Franklin Active Adult Center Project
Change Order Summary

Change Order # Between Dewees Construction Inc. and Owner
Contract Number: 24-102 Change Order # Two

PROPOSAL REQUEST

PR-03 Narrative:

C201

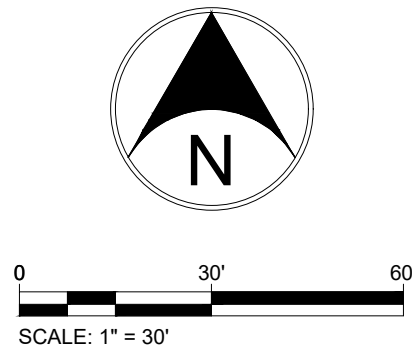
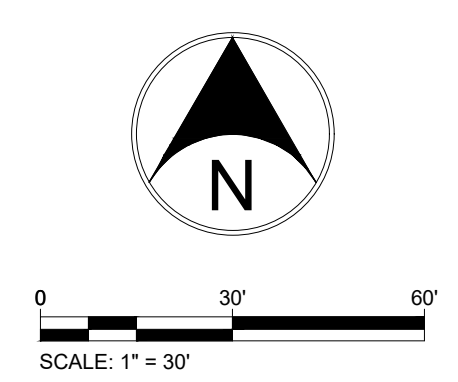
1. Civil:
 - a. Sheets C201 and C301: Add a sidewalk from the southwest exit of the Events Room south to Water Street.
2. Architectural:
 - a. Sheet G002: Provide signs as shown to call out maximum occupancy allowed in assembly spaces.
 - b. Sheet A001: Add sign detail as shown.
3. Electrical:
 - a. Sheet E201: Add exit sign and Emergency Wall Pack light in Passage 32.
 - b. Sheet E301: Add exterior horn strobe on south wall at Game Room 15 and Pull Station at Water/Fire Protection 04.

8. Hard surface walkway to publicway southwest exit door (showing landing only)	Added to Site Plan C201 and Grading Plan C301.
9. Occupant load signs in ... Events, Auditorium, game room and meeting library	Added to notes on Life Safety Plan sheet G002 & an Occupancy Sign detail on A001.
